**SUBJECT:** Temporary Beach Access Routes Report and Pilot Program

# **Site Accessibility Evaluation**

**Temporary Beach Access Routes**

Public Beach Hermosa Beach, CA 90254

#### Finding: 2

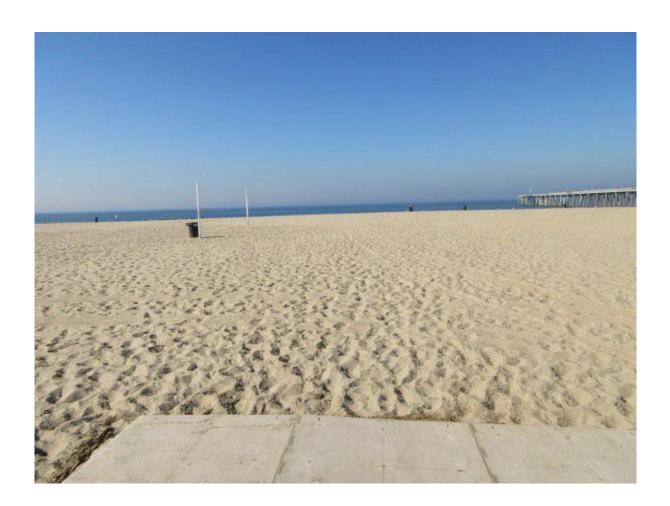
It has been proposed that the existing temporary accessible beach access route be extended closer to the ocean. However, there is a volleyball court within the projected alignment of the existing beach access route.

The additional beach tiles will create a hazard when placed too close to a sport court of any kind.

To avoid proximity to the sport courts, an alternative route with an equivalent view of the ocean breaking onshore (at mean low tide) may be installed that measures approximately 275 feet from The Strand.

When a seasonal sand berm is in place, the length of the alternative beach path shall provide equal access to the beach activities that typically take place on the land side of the sand berm. It is estimated the length of the temporary beach path should be approximately 170 linear feet to provide an equivalent view looking north.

The proposed path is

obstructed.

Several locations were considered and the location that offers the most amenities for a temporary accessible beach access route is located just south of the existing public restrooms at Pier Plaza. See the Site Sketch attached as Exhibit A to this report. Considerations for this location included but were not limited to: the proximity to the public restrooms, showers, the Pier, and public accommodations provided by nearby hotels, restaurants and retail locations at Pier Plaza.

#### Finding: 15

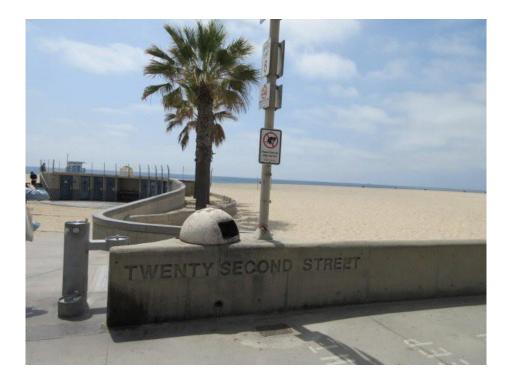
The proposed removable beach access routes shall not contain a running slope that is greater than 10%.

The running slope of any segment of an outdoor recreation access route shall not be steeper than 1:10 (10%).

Install and maintain the beach access route with the least amount of running slope and as discussed above, the running slope shall not to exceed 10%.

#### Finding: 17

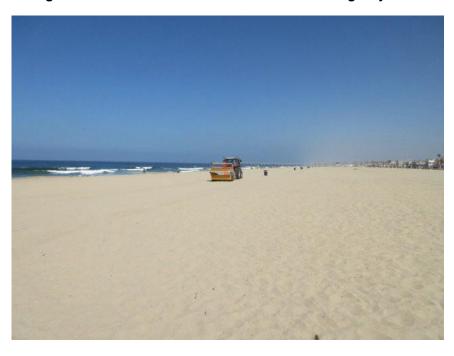
(2015 ABA 1018.2 Connections.) Beach access routes shall connect an entry point to the beach to the:

- 1. High tide level at tidal beaches;
- 2. Mean high water level at river beaches; or
- 3. Normal recreation water level at lake, pond, and reservoir beaches.

The proposed temporary removable beach access routes shall extend as close as feasible to the high tide level of the beach. The distance is estimated to between 275 and 350 linear feet. A compliant resting interval/ turning space (2% in all directions) shall be provided at the end of the beach access routes. The resting interval should not be located within the emergency vehicle drive or other vehicular lanes.

# **EXHIBIT "A"**Temporary Accessible Beach Access Route

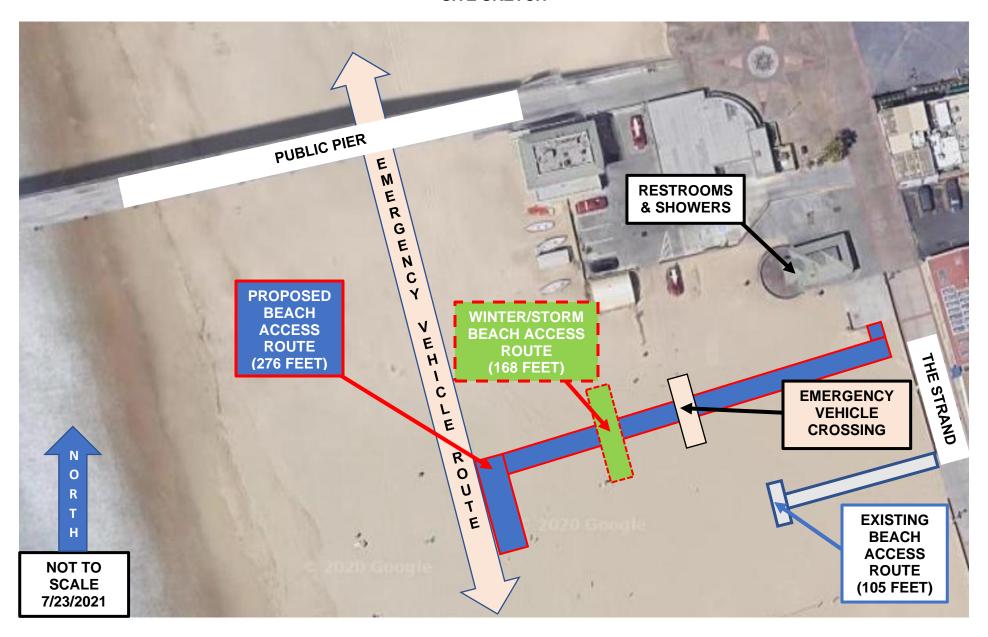
- 2(a). Proposed Temporary Accessible Beach Access Route Several locations along The Strand were reviewed and considered as a part of this evaluation and it was determined the existing temporary accessible beach access route be relocated to begin just south of the existing restrooms located to the south of the Pier and head toward the ocean. The equivalent view of the ocean breaking onshore (at mean low tide) measured approximately 275 feet from The Strand. The accessible route shall be a safe distance away from sport courts (e.g., volleyball courts) and play areas such as swing sets. See Exhibit A.

- 2(b). Proposed Temporary Accessible Beach Access Route with Sand Berm Protection in Place (Winter/Storm) The location of the temporary accessible beach access route may be at the location indicated above in 2(a). However, while the County's sand berm is in place for the winter months or during storm events, the accessible beach access route should be reduced to end at a safe distance from the sand berm, approximately 168 linear feet. See Exhibit A.

# **EXHIBIT "B"**Removable Beach Access Route

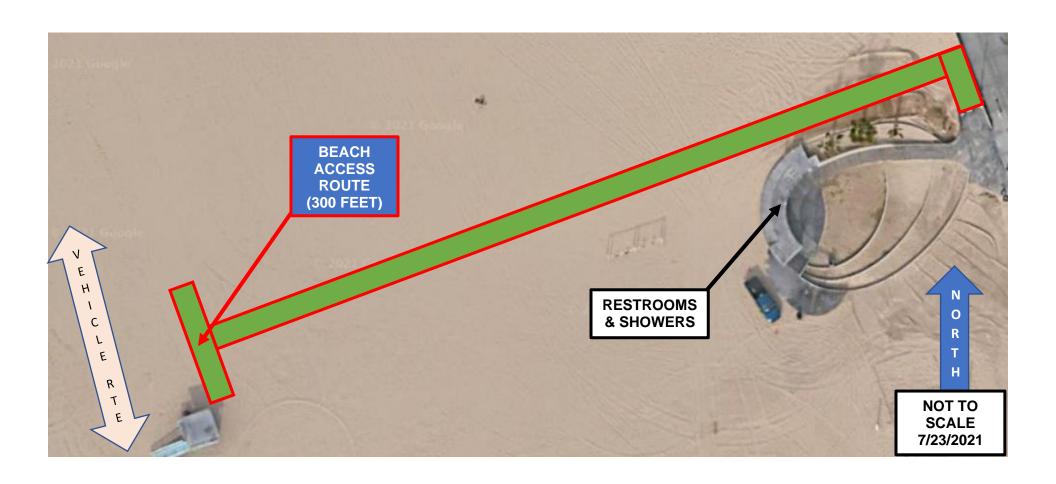
- 3. Temporary Removable Beach Access Routes (Roll-Out Mats) As an alternative or in addition to the existing Temporary Accessible Beach Access Route discussed above, beach access routes made up of roll-out mats ("Removable Beach Access Routes") may be provided anywhere there is a connection point from The Strand and where an accessible parking space(s) is in close proximity to the route(s). It is recommended the beach access routes be located near public restrooms and on largely flat surfaces. Two locations for Removable Beach Access Routes were evaluated as a part of this study. These proposed routes are located adjacent to 2nd Street and 22nd Street. The removable beach access routes shall be a minimum 5 feet wide and extend to as close to the ocean (at high tide) as feasible and meet the additional criteria outlined in this report. Additionally, the Removable Beach Access Route(s) shall be a safe distance away from sport courts (e.g., volleyball courts) and play areas such as swing sets. NOTE: There should be a compliant resting interval and/or turning space at the end of the route that is relatively level in all directions and located outside the emergency vehicle lane. See Exhibit B.
